NEC® Code-Making Panel 11 First Draft Meeting Agenda

January 18 - 20, 2024

National Electrical Code®

Date: May 12, 2023 10:42 AM

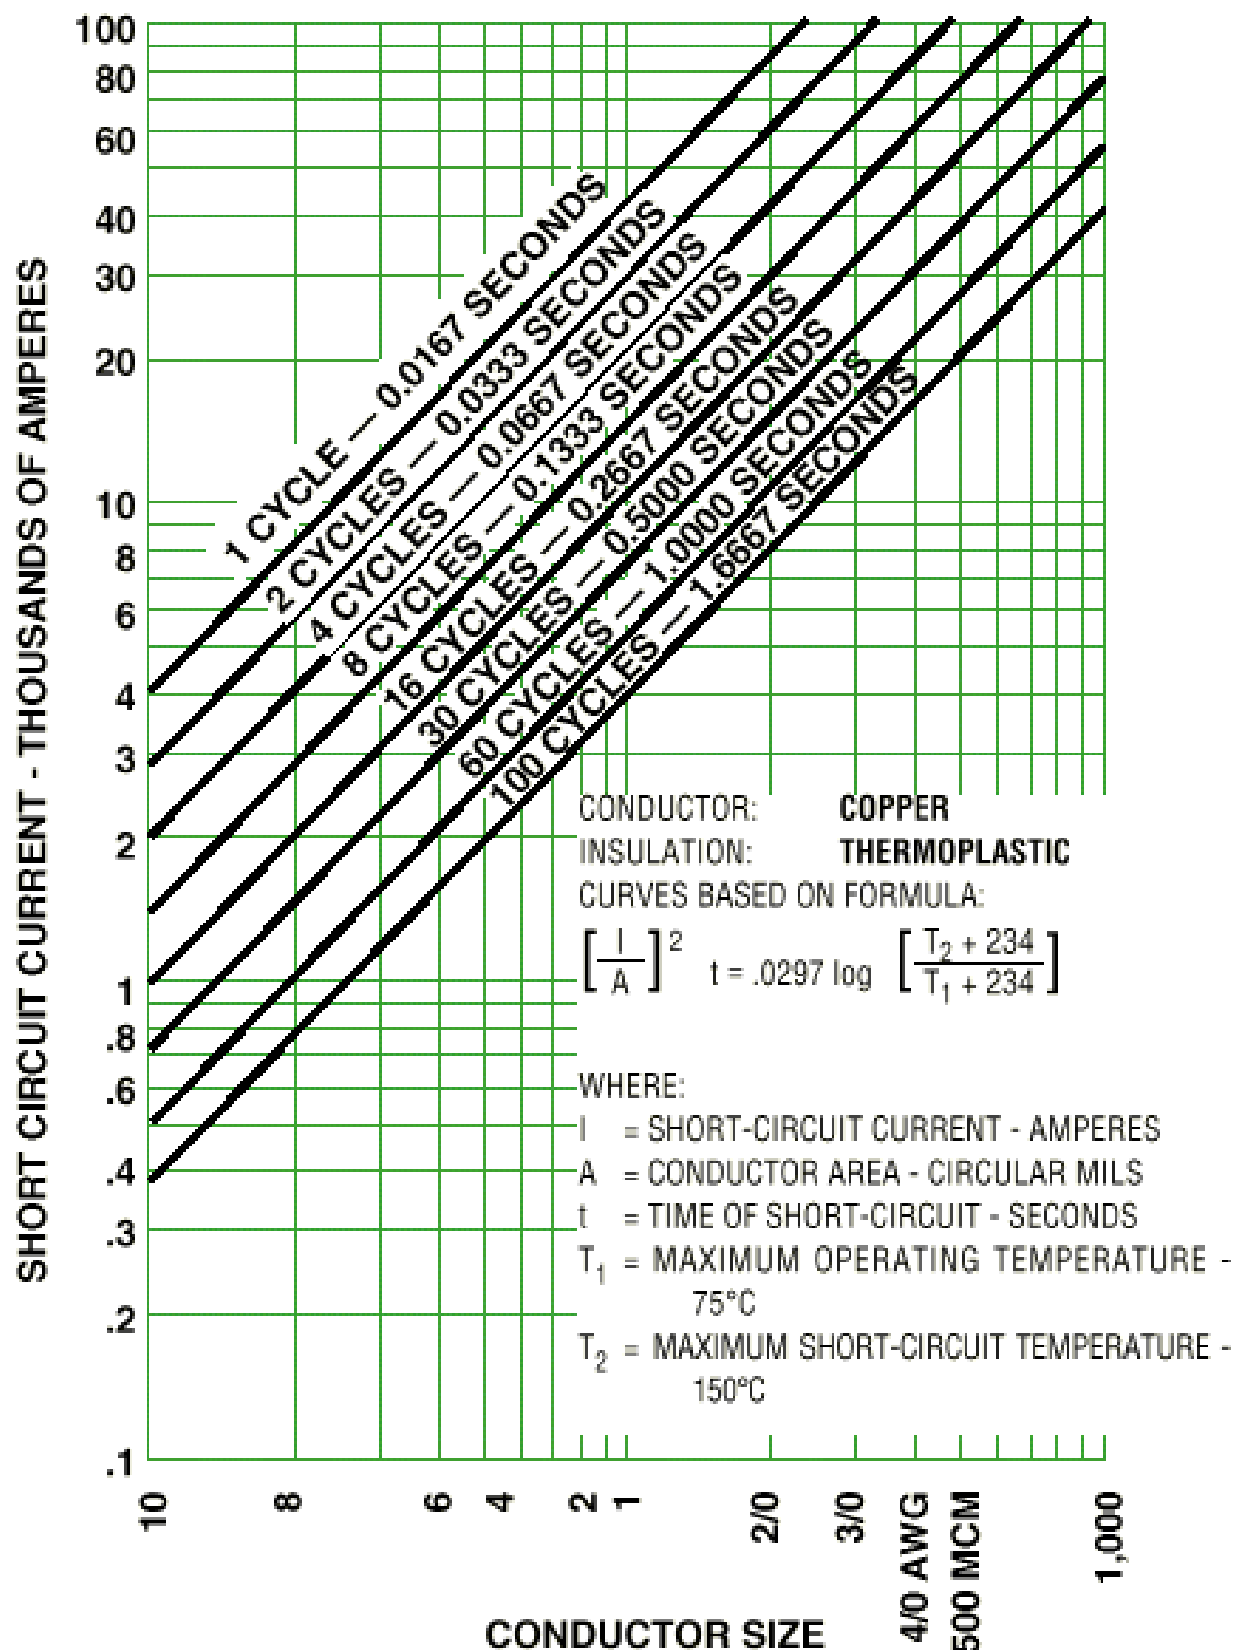
In 430.52(C)(3)(b)(2)a. of the 2023 National Electrical Code, a value of 1300 percent is specified for all motor types in Table 430.52(C)(1) other than Design B energy efficient and Design B premium efficiency. Since the introduction of Design BE and CE introduces a new exception to the 1300 percent specification, it is proposed to specify a value for each of the motor types shown in Table 430.52(C)(1) instead of specifying a single value with a list of exceptions. This does not change the adjustable instantaneous-trip setting specified in 430.52(C)(3)(b)(2) of the 2023 National Electrical Code for any motor type with the exception of the Design BE and CE, energy-efficient Design C, and premium efficiency Design C motor types already mentioned.

<u>File Name</u>	<u>Description</u>	<u>Approved</u>
equivalent_HP_ratings.pdf	HP rating of multi motor equipment

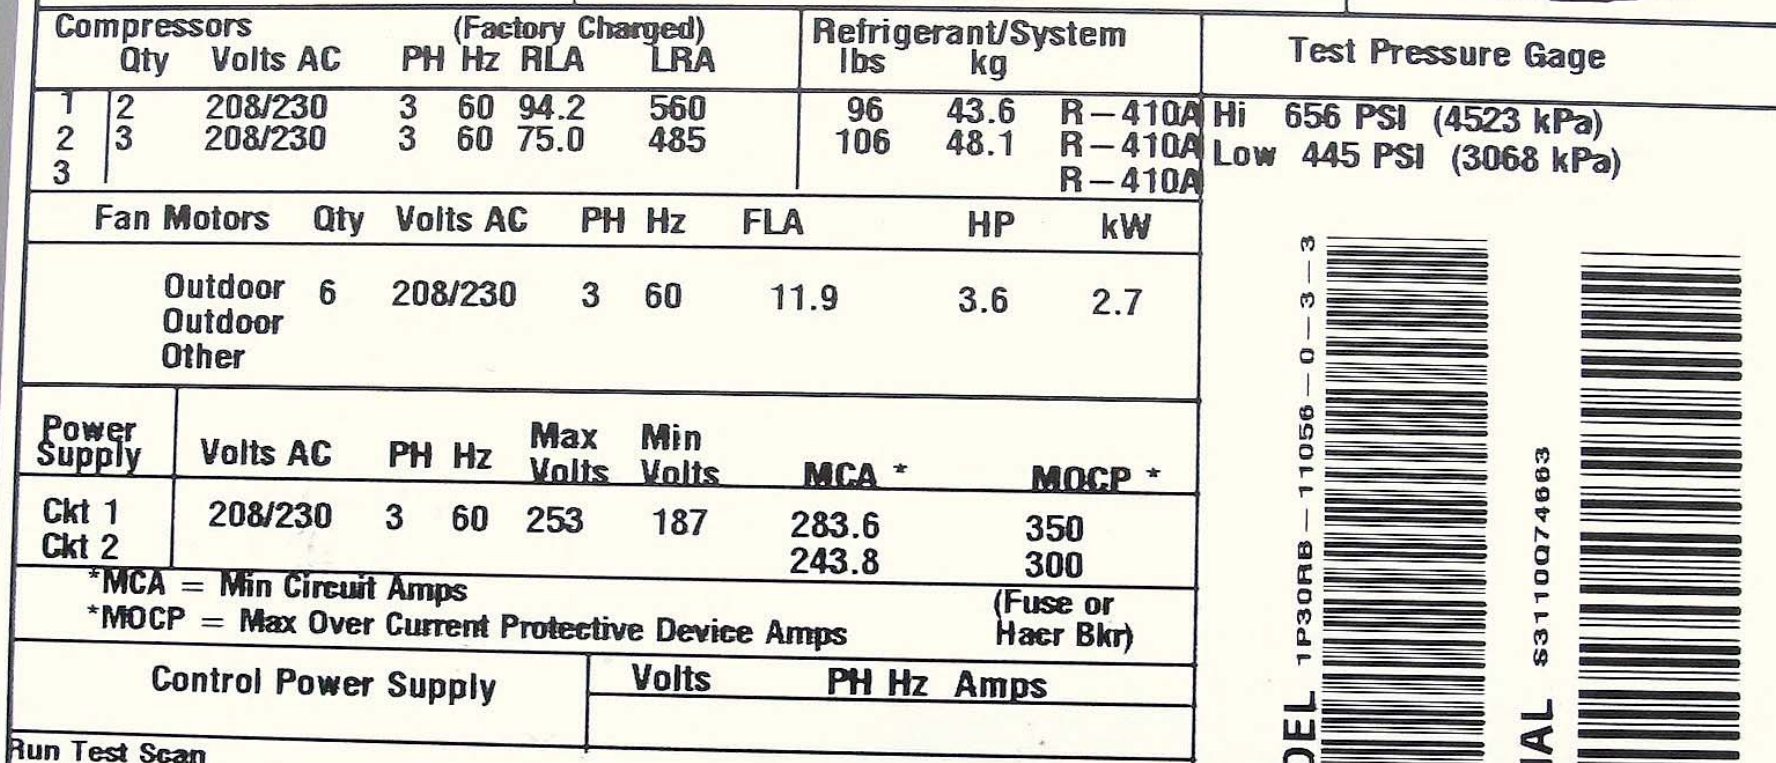
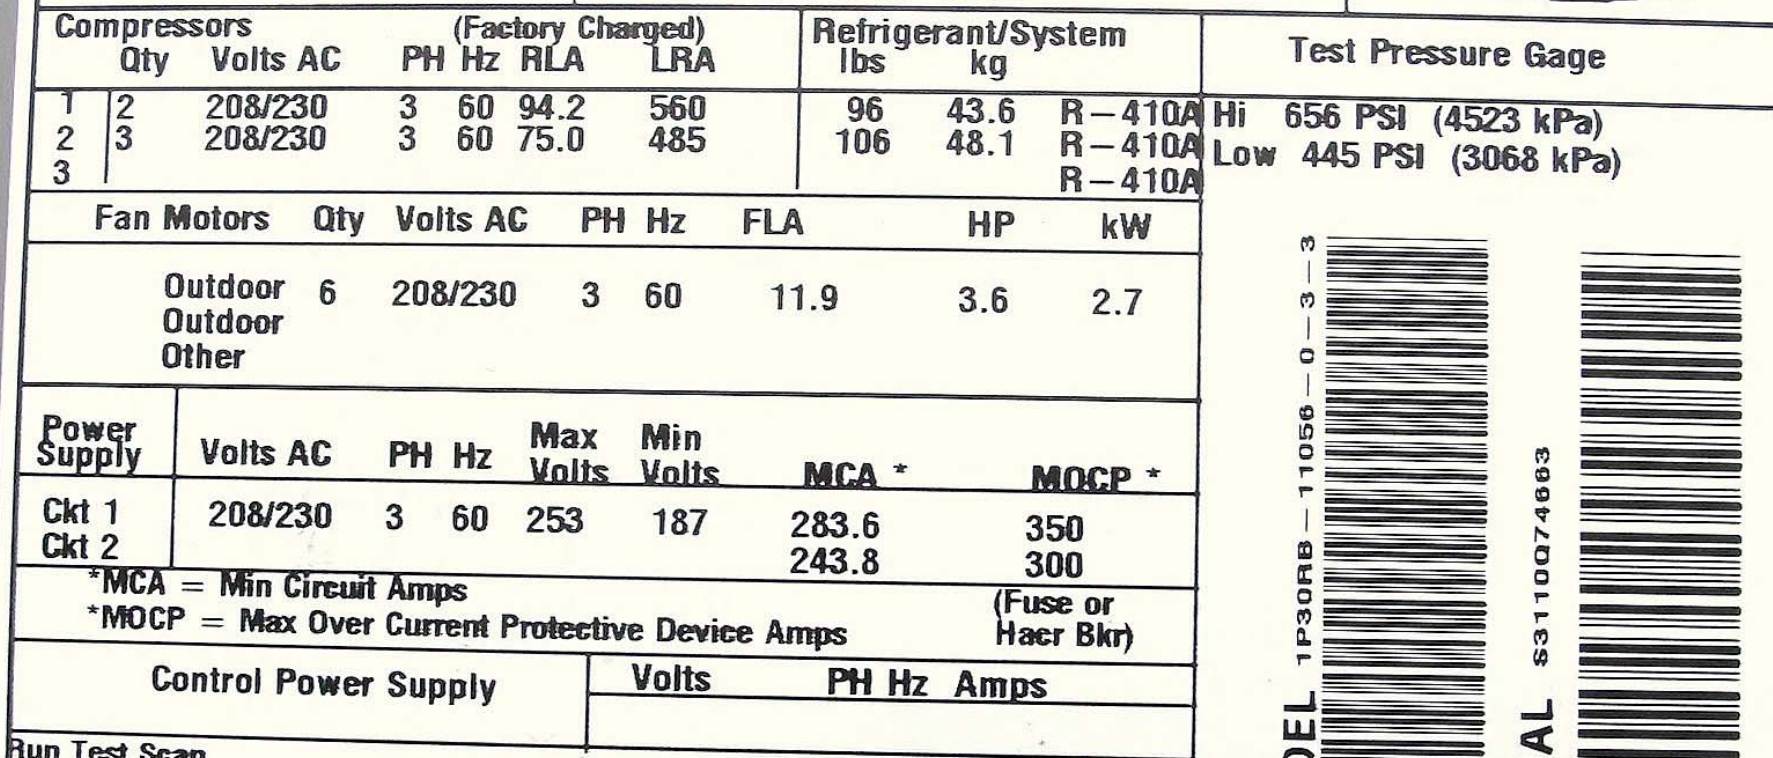
This PI is in conjunction with PI 485, 486, and 487 addressing the horsepower rating for factory-wired multimotor and combination-load equipment. I believe these revisions are necessary to help installers, designers, and inspectors ensure the correct disconnecting means for factory-wired equipment is used. Determining the equivalent horsepower rating for factory-wired equipment is often overlooked. If the manufacturer does the calculations and provides that information on the equipment nameplate, then installers, designers, and inspectors will have a much easier time verifying that the correct disconnect rating is used.
